MEYLE No. 300 333 2104/HD
Reference No. 33 32 6 770 786

Subframe mount, axle carrier to fit BMW E36, E46, E83, E85, E86

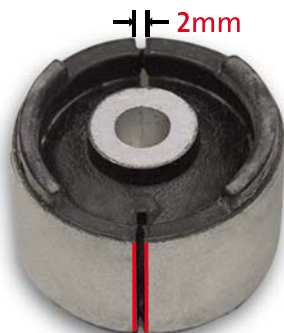
Premature wear causing excessive free play in the rear trailing arm bushings

- Comprised rear suspension control and responsiveness
- Loss of driving comfort and safety

- Use of a radial expansion bushing with a slotted outer sleeve comparable in performance to the BMW sports version
- Higher bushing pre-load

Firm and positive rear suspension response and a longer expected service life
